WATER QUALITY MEMORANDUM Utah Coal Regulatory Program

RE: 2010 1st Quarter Water Monitoring, Canyon Fuel Company (CFC), LLC, Dugout Mine, C/007/0039-WQ10-1, Task ID #3475

Stream Monitoring Site PC-2

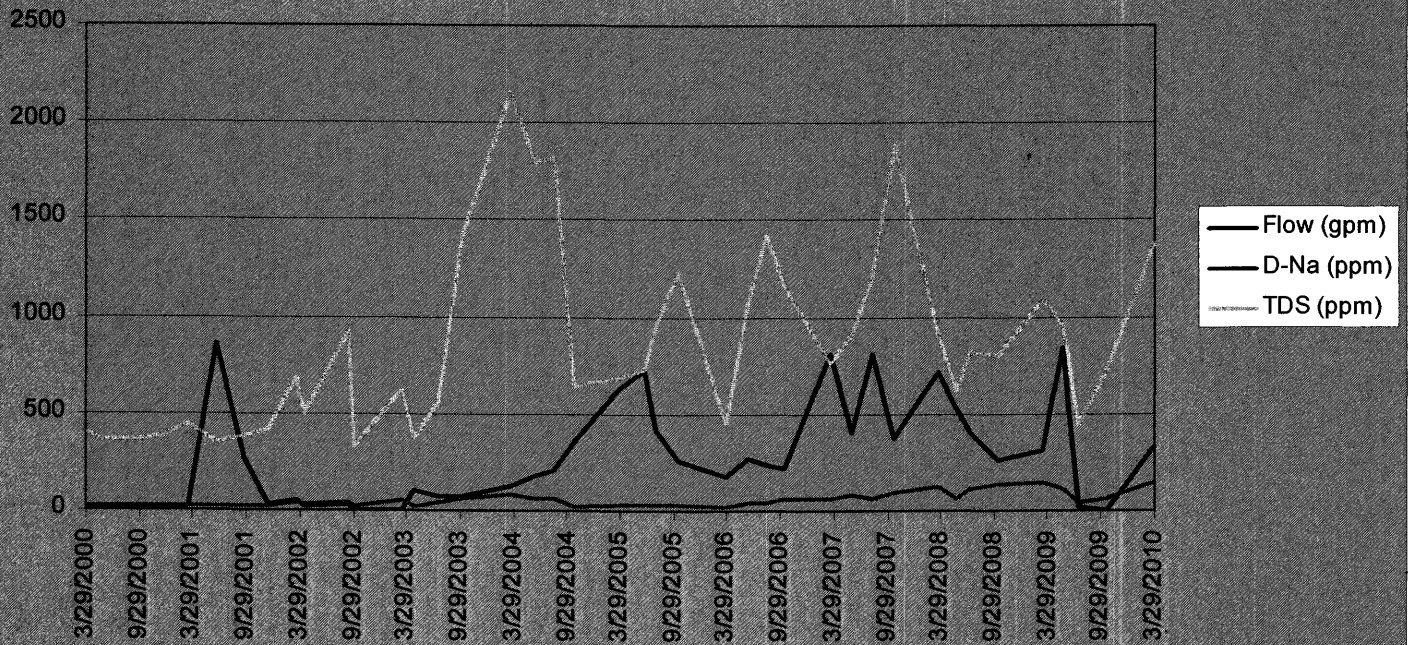
Site PC-2 has developed an upward trend in TDS and its associated components. The previous three quarters had shown an upward trend in TDS and this quarter continued that trend with elevated values reported for field conductivity, D-Ca, D-Mg, D-K, D-Na, Cl, SO₄, TDS, T-Cations and T-Anions (See chart below). The water quality standard for Pace Creek (as established by the Division of Water Quality) is 3,000 mg/L. The reported TDS value for this quarter is 1,150 mg/L. Although the concentrations are well within the standard, continued monitoring will be conducted.

Continued monitoring of stream monitoring sites DC-1, DC-2, FAN and PC-2 for upward trends in TDS and its chemical constituents.
